RESOLUTION NO. 09-296

A RESOLUTION OF THE CITY COMMISSION OF THE CITY OF KEY WEST, FLORIDA, AWARDING THE BID OF CHARLEY TOPPINO & SONS, INC., FOR THE WHITE STREET STORMWATER PUMP STATION PROJECT IN AN AMOUNT NOT TO EXCEED \$1,645,000.00; PROVIDING FOR AN EFFECTIVE DATE

RE: **Approval of a Bid of \$1,645,000 from Charley Toppino and Sons for the Construction of White St. Stormwater Pump Station**

The following change is hereby made part of WHITE STREET STORMWATER PUMP STATION, as fully and completely as if the same were set forth therein:

| WHITE STREET STORMWATER PUMP STATION | SHEET NO. D-2 |

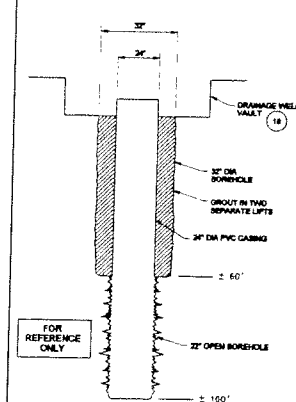
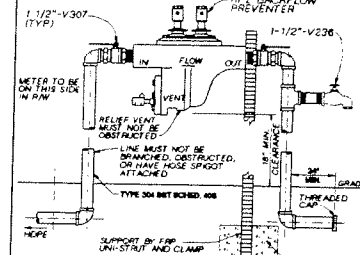
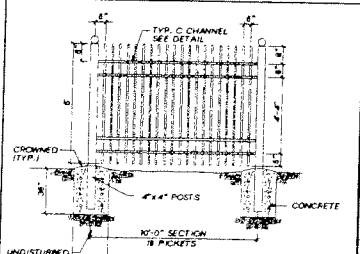
Drawing D-2

DELETE and REPLACE in its entirety with the attached Drawing D-2.

Drawing E-3

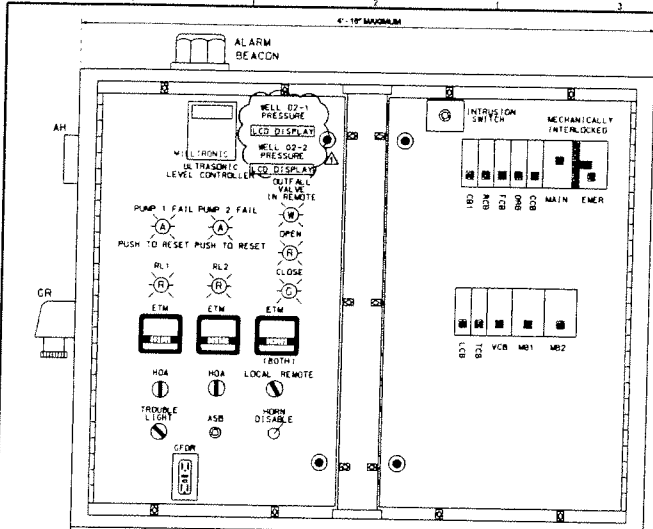
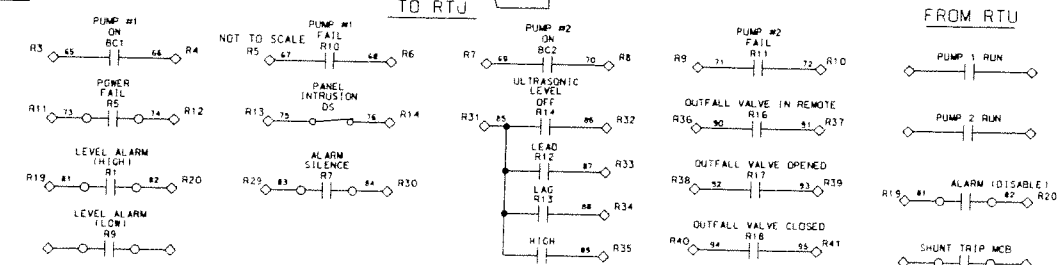
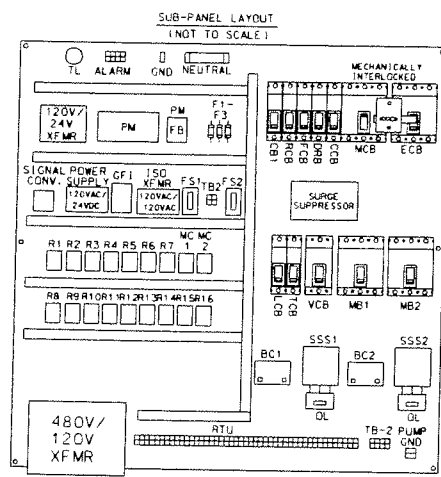
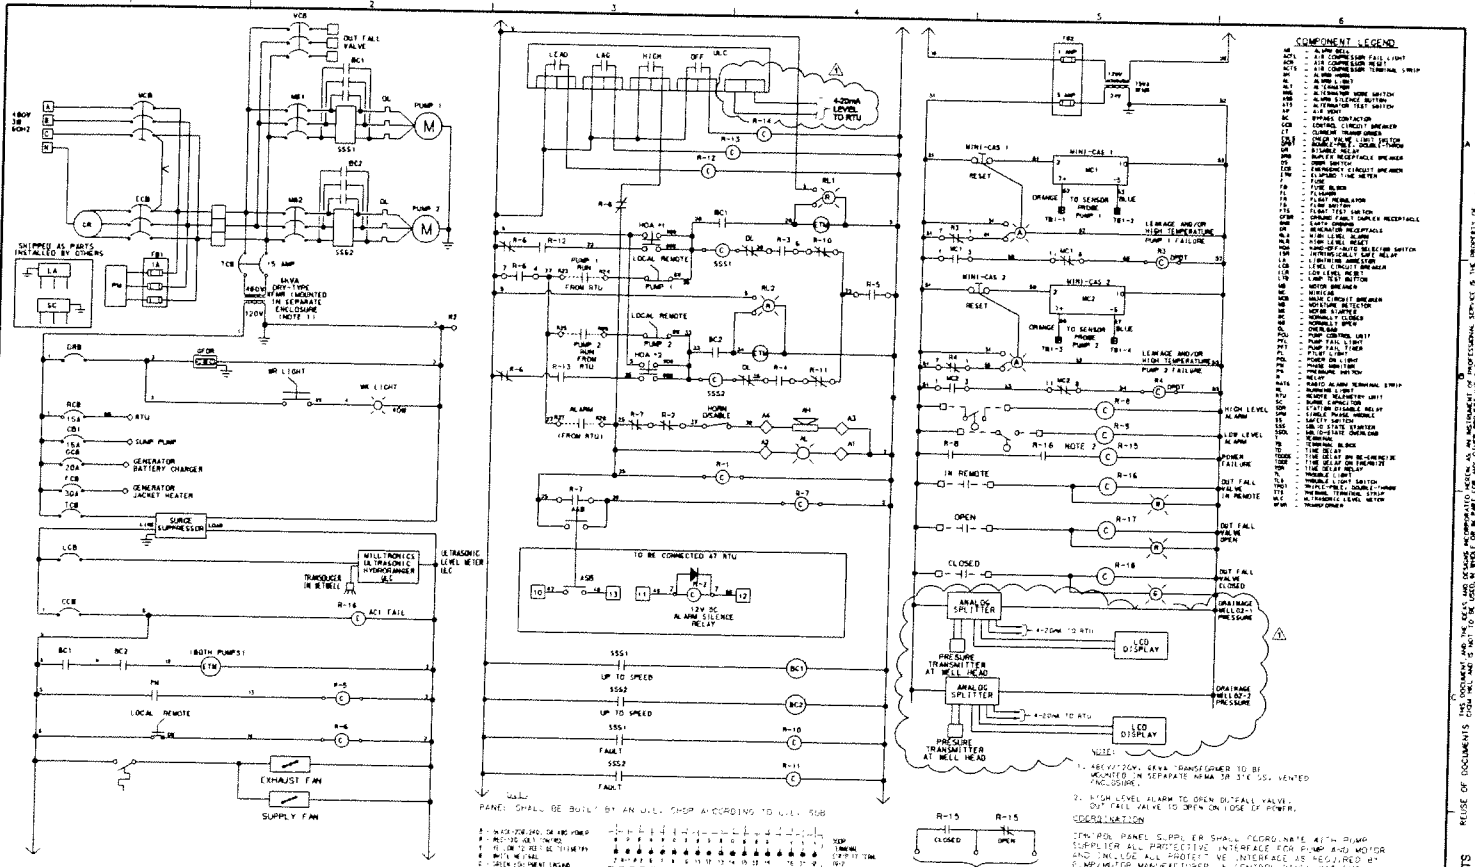
DELETE and REPLACE in its entirety with the attached Drawing E-3.

| PLAN AND SECTION | | NO. | 2027-B |

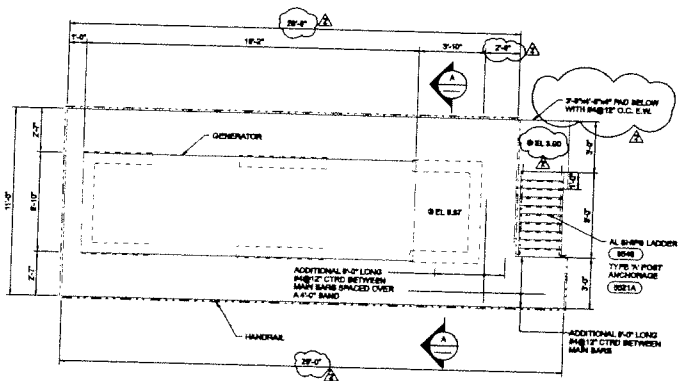
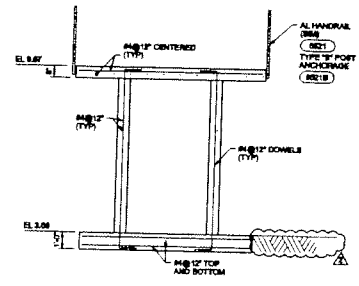
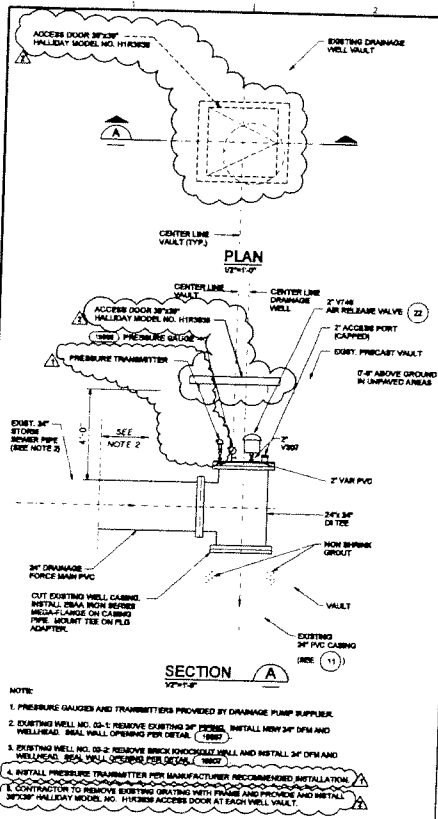
| 10608 | | | | | ADDED NOTE FOR ANCHORING GENERATOR TO PLATFORM |

| STANDARD DETAILS | SHEET D-2 |

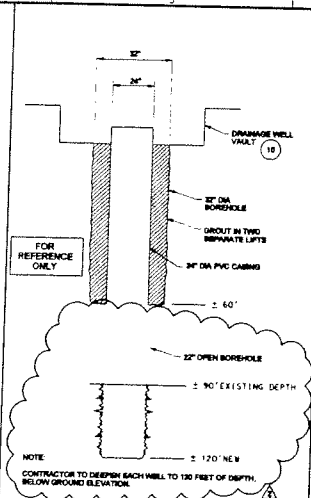
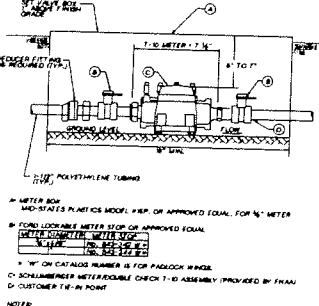
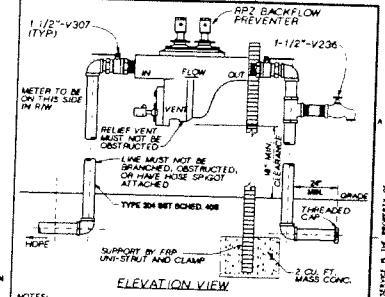
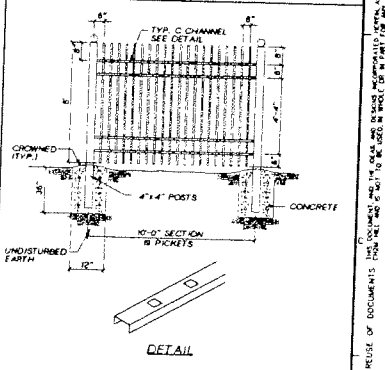
Drawing D-2

DELETE and REPLACE in its entirety with the attached Drawing D-2.
